IEEE802.3 Open Revision Requests

Order by Request Number

Figure 33-6—PSE state diagram

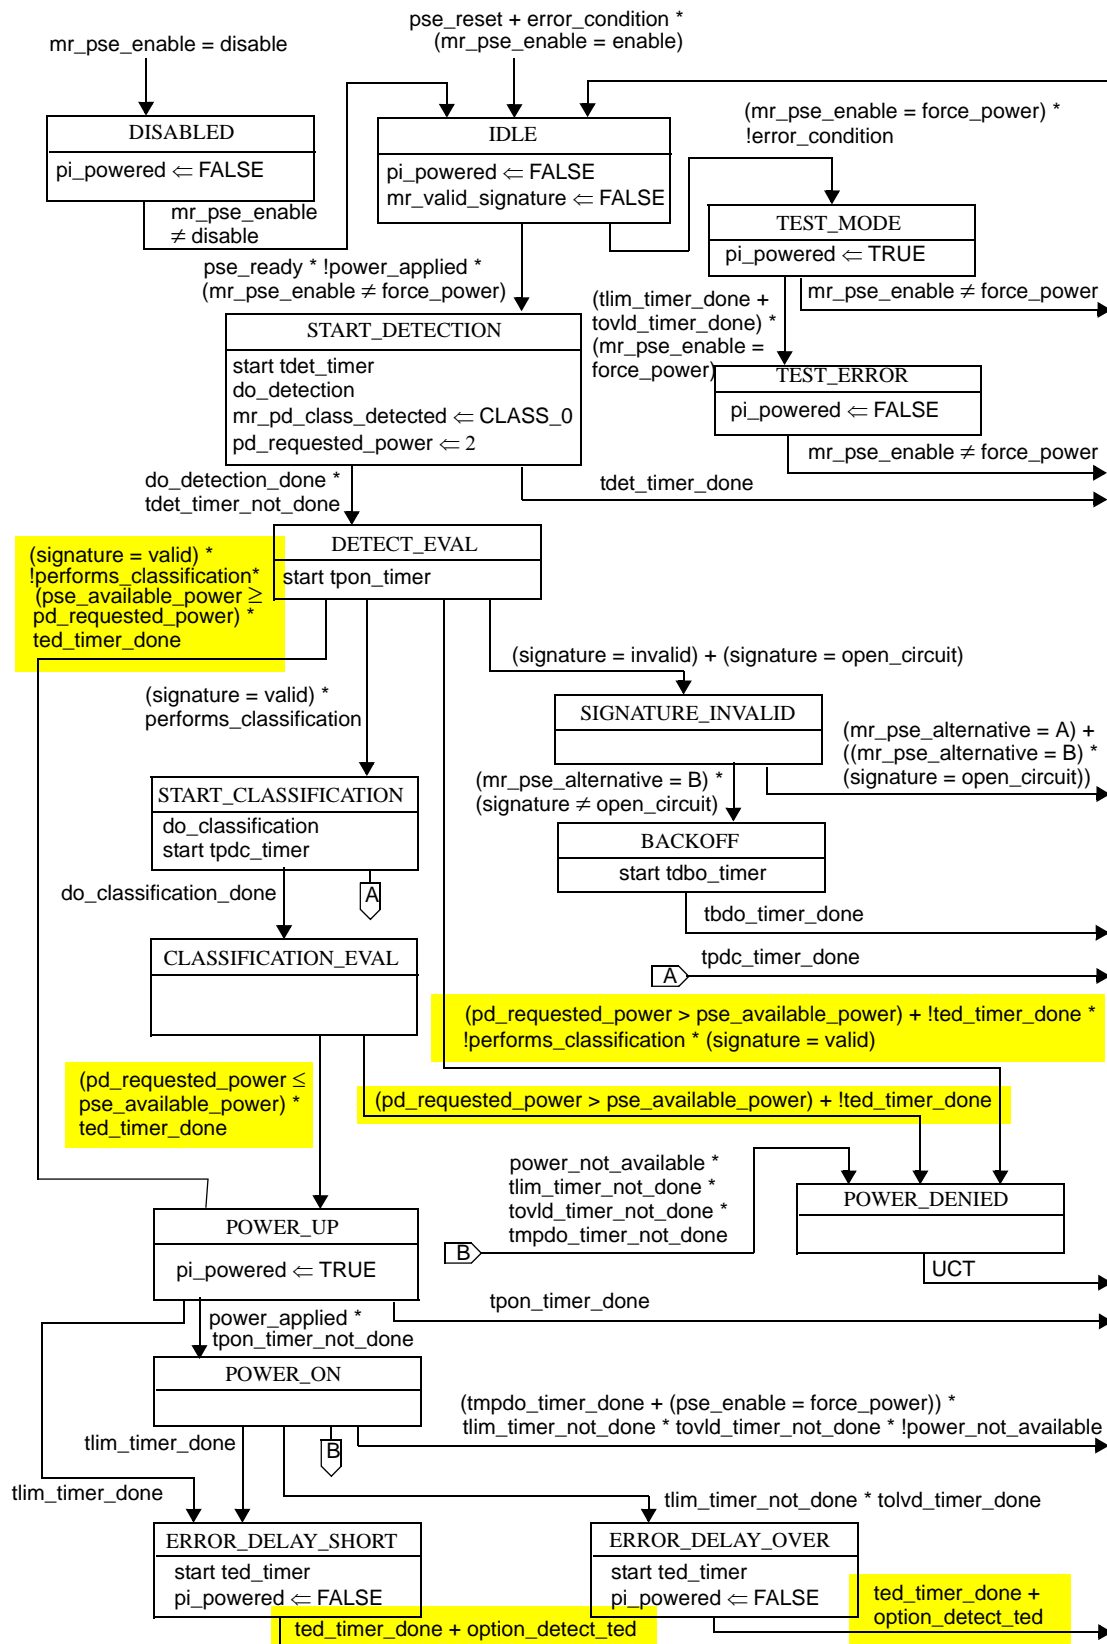
Add new variable OPTION_DETECT_TED to 33.2.3.4

Change state machine per attached markup.

The current state machine prevents detection during a TED_TIMER interval, which is a valid mode of operation (per my comment 28 against 802.3af-D4.1). This change allows this alternate mode of operation without breaking current hardware.

33.2.3.7 State diagrams (replace figure 33-6 with the following - changes highlighted)

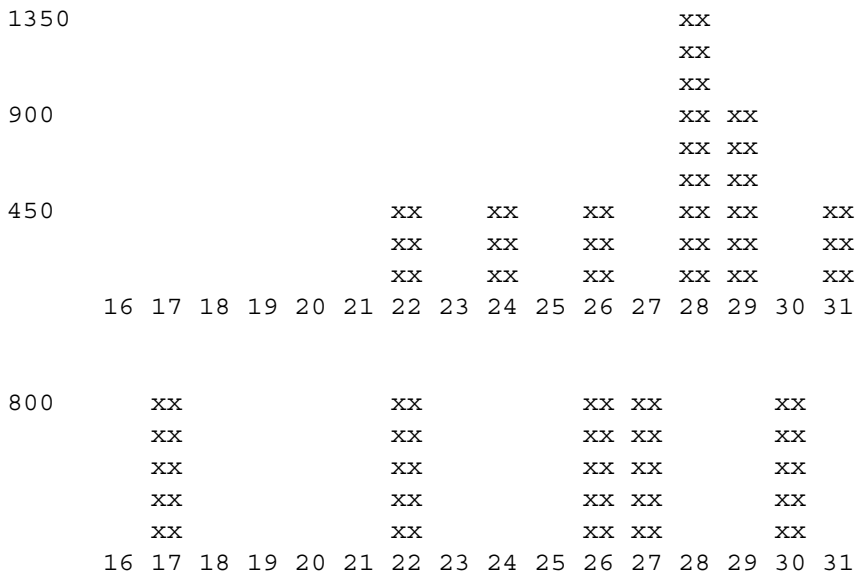
Within bullet item (d) remove the word uniform, allowing the sentence to read "...r is a randomly distributed number between 16 and 31..."

The plots on show simulations of what the ||A|| spacing would actually look like when the pseudo-random generator is sampled in this manner. The first plot shows the distribution of ||A|| spacing for the X^7+X^6+1 polynomial, and the second plot uses the X^7+X^3+1 polynomial. The x-axis shows the number of columns between consecutive ||A|| columns. The y-axis shows the number of times that ||A|| spacing existed. For each simulation, 4096 trials were done. It is clear that after several thousand trials, there are many spacing values that have not been used, thus making it impossible to have a uniformly distributed spacing.

Figure 28C-1—Message code #5 sequence

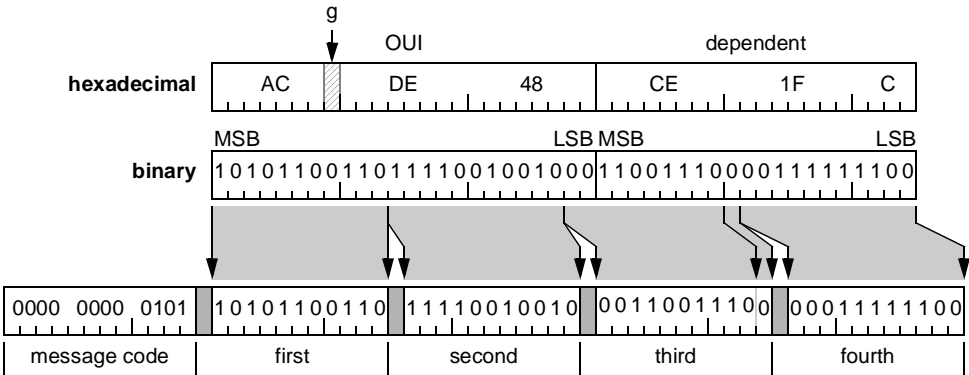
- 1) Bit-specification wording is very hard to follow; a figure is needed.
- 2) The bit ordering within-byte ordering is unclear, given the conflicting meanings applied to "MSB" by the IEEE/RAC and following 28C.8.

Proposed solution (follows).
 Notes: If another bit ordering was intended, then change the figure accordingly.

Insert the following text at the end of subclause 28C.6:

For example, assume that a manufacturer's IEEE-assigned OUI value is AC-DE-48 and the manufacturer-selected user-defined user code associated with the OUI is 1100 1110 0001 1111 1100₂. The message code values generated from these two numbers is encoded into four message codes, as specified in Figure 28C-1. For clarity, the position of the global broadcast g is illustrated.

Figure 28.1—Message code #6 sequence

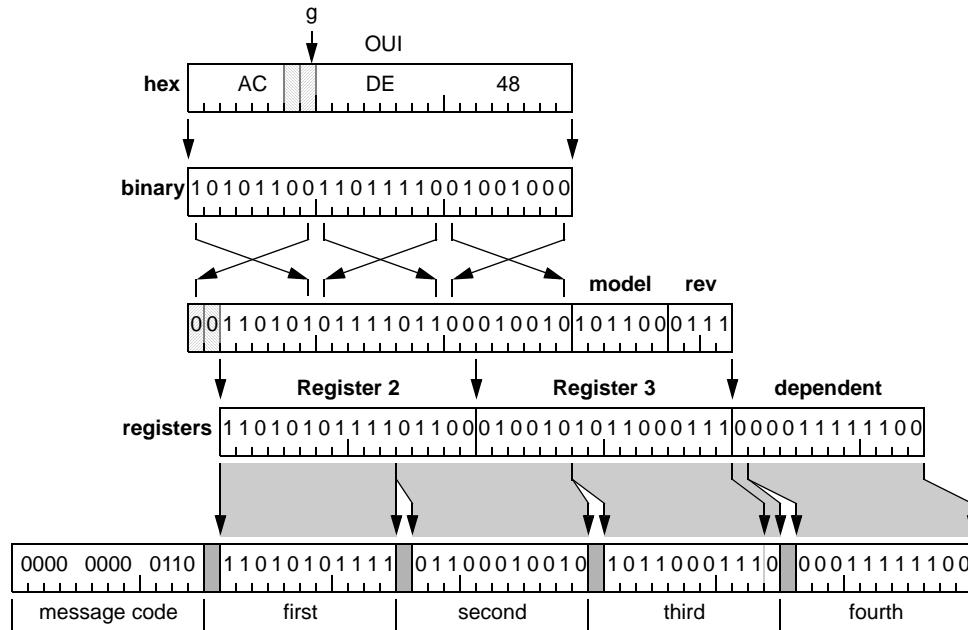
- 1) Bit-specification wording is very hard to follow; a figure is needed.
- 2) The bit ordering within-byte ordering is different from the IEEE/RAC usage, and should therefore be very clearly illustrated.

The PHY ID tag code message shall consist of a single shall consist of a single message code of 0000 0000 0110₂ followed by four user codes. For example, assume that a manufacturer's IEEE-assigned OUI value is AC-DE-48, the manufacturer's model number is 101100₂, manufacturer's revision number is 0111₂, and the PHY-dependent information is 000011111100₂. The message codes generated from these values are encoded into four message codes, as specified in Figure 28.1. For clarity, the position of the global broadcast *g* is illustrated.

Figure 7-6—PLS Input and Data_Valid function

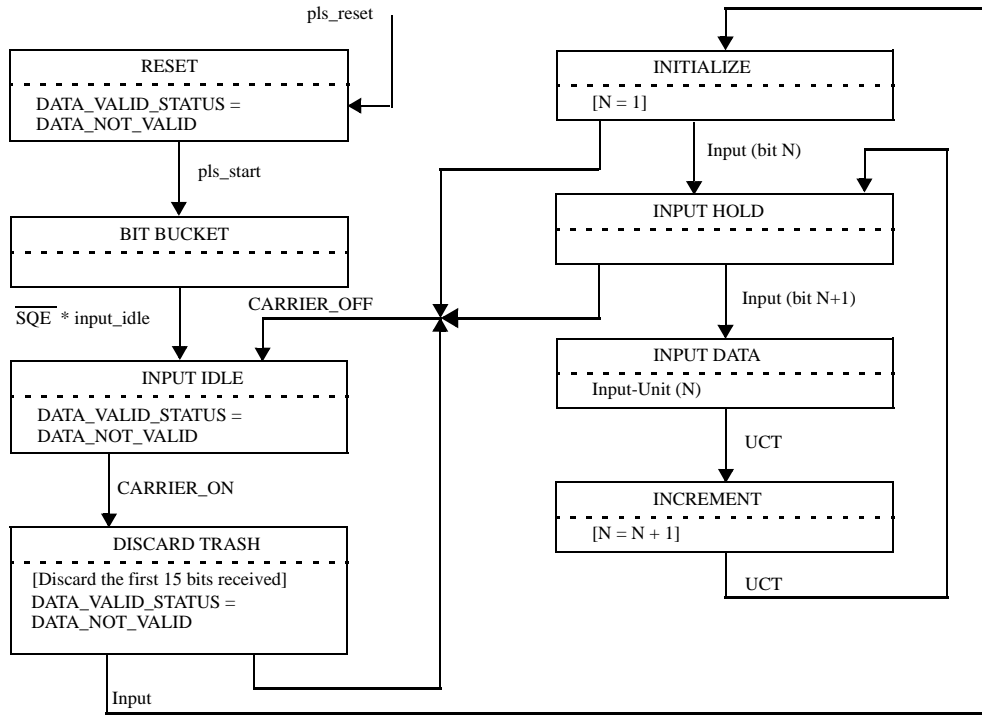
REQUESTED REVISION:
STANDARD: IEEE Std 802.3-2002
CLAUSE NUMBER: Figure 7-6
CLAUSE TITLE: PLS Input and Data_Valid function

Change text from "SQE * input_idle" to "not SQE * input_idle". The not applies only to SQE.

Error when figure was converted from 1996 version.

Replace Figure 7-6 with the following:

Figure 27-1—100BASE-T repeater set relationship to the ISO/IEC OSI reference model

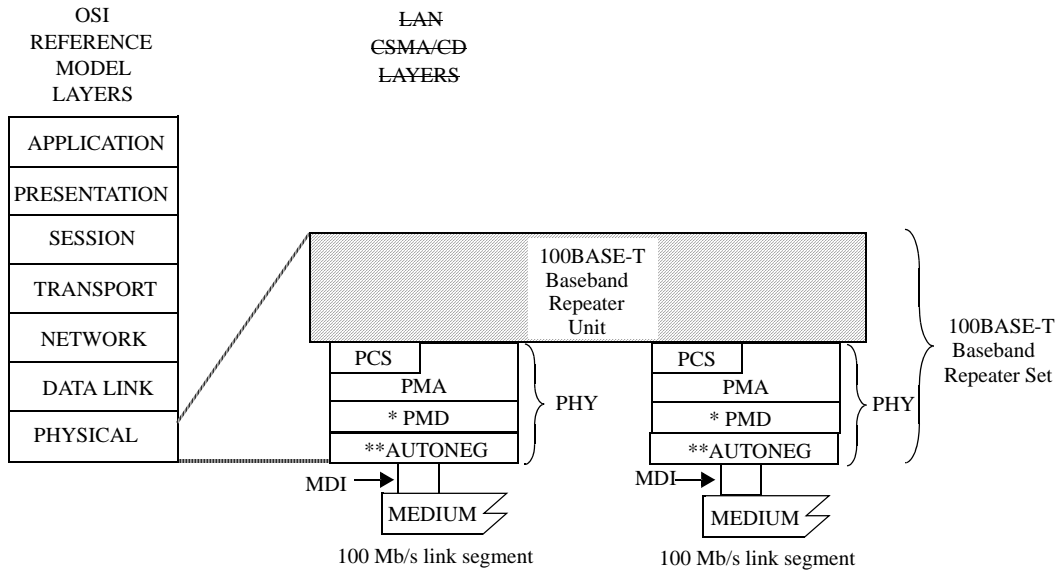
REQUESTED REVISION:
STANDARD: IEEE Std 802.3-2002
CLAUSE NUMBER: Figure 27-1
CLAUSE TITLE: 100BASE-T repeater set

Remove text

Figure has text hanging out in midspace with no attachment to a layer.
Figure in Clause 41 has more detail and text has a reference point.

Change Figure 27-1 as follows:

Figure 40C-2—Auto-Negotiation Transmit state diagram add-on for 100BASE-T

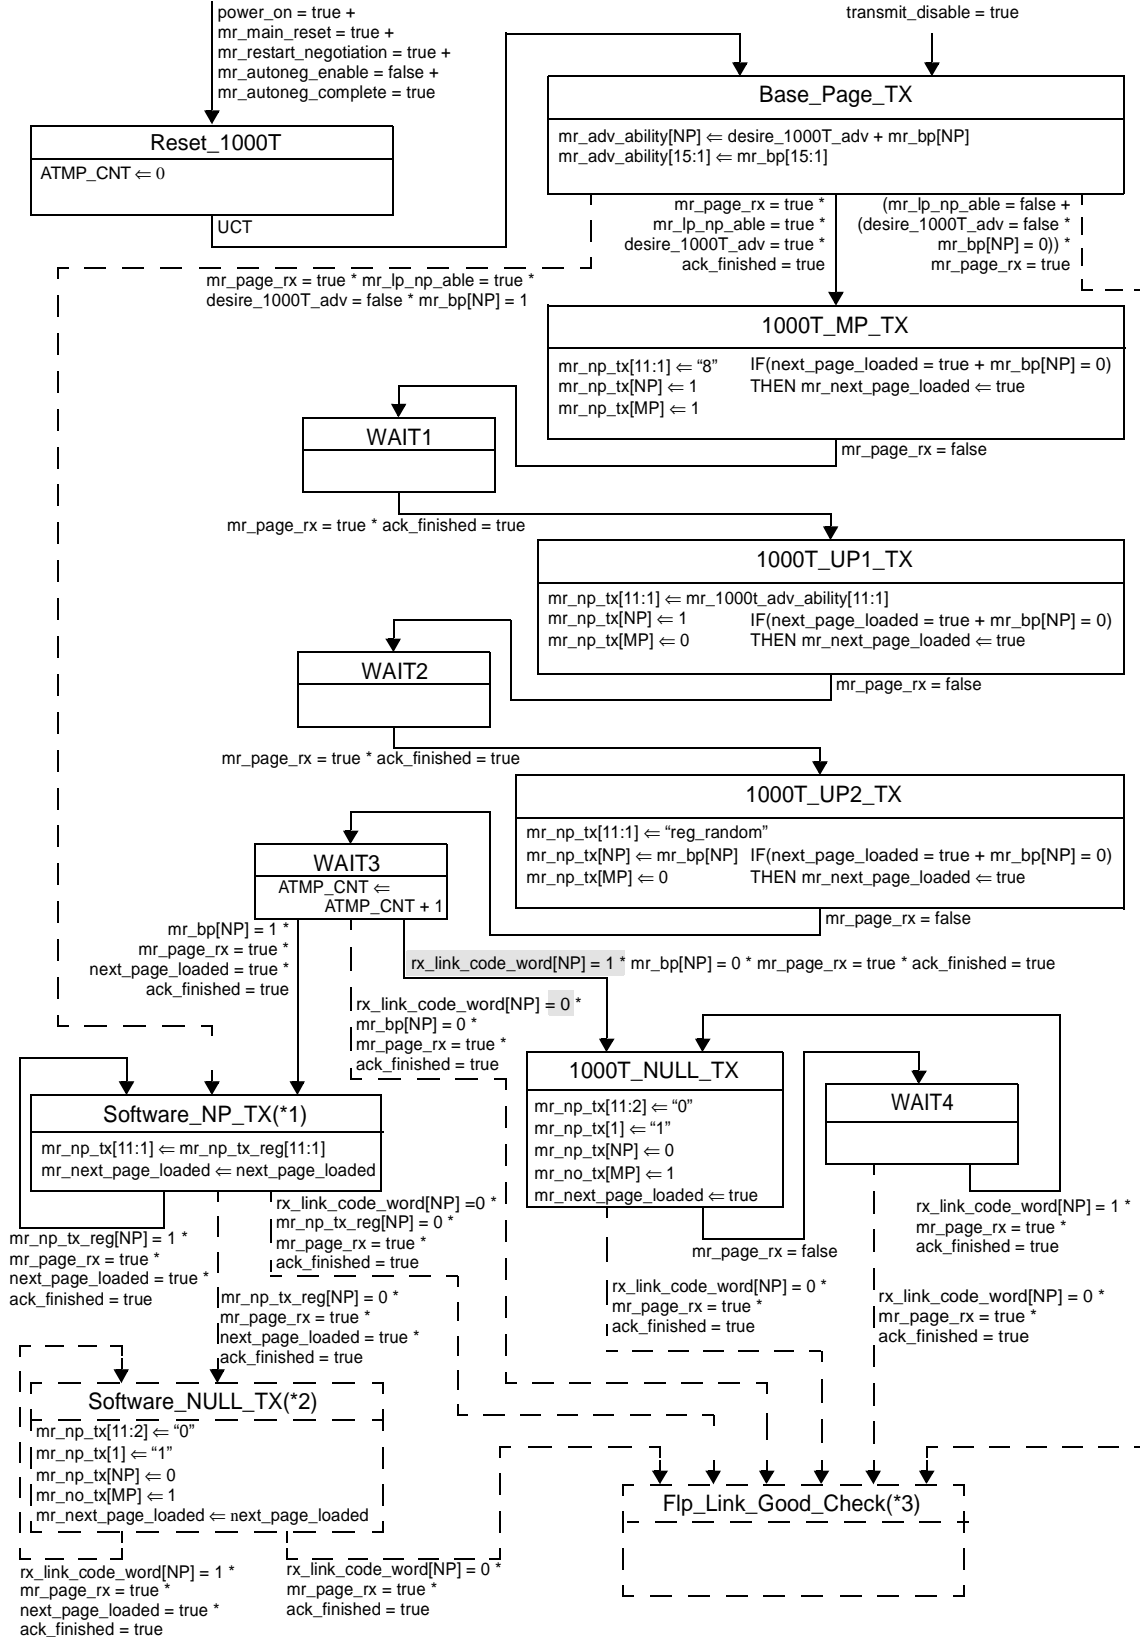
REQUESTED REVISION:
STANDARD: IEEE Std. 802.3-2002
CLAUSE NUMBER: 40C.2.1 and Figure 40C-2
CLAUSE TITLE: Auto-Negotiation Transmit state machine add-on
for 1000BASE-T

In Figure 40C-2, in the transition conditions between WAIT3 and
Flp_Link_Good_Check, change the transition condition from
rx_link_code_word[NP]=1 to rx_link_code_word[NP]=0.

Furthermore, rx_link_code_word[NP]=1 should be added to the transition
conditions between WAIT3 and 1000T_NULL_TX.

Replace Figure 40C-2 with the following (Changed highlighted):

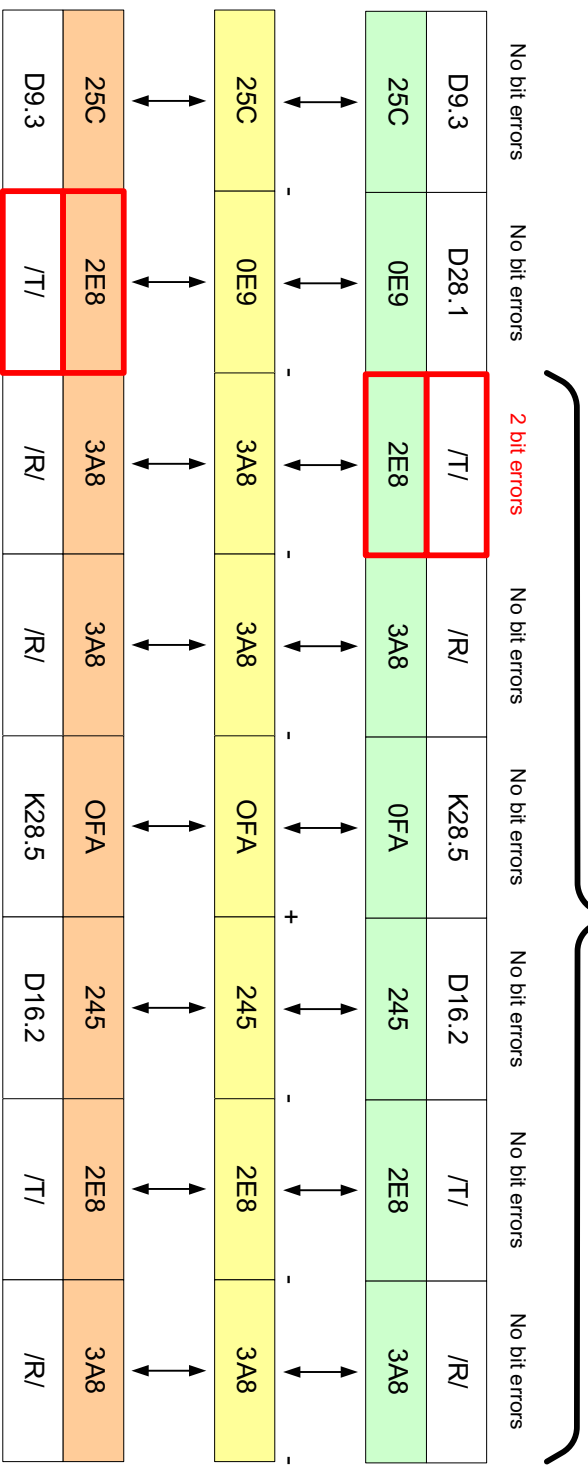
Page 2 in the attached diagram shows the increased Hamming distance when a modified T_FEC_E is used.

This modification may make FEC function not backward compatible.
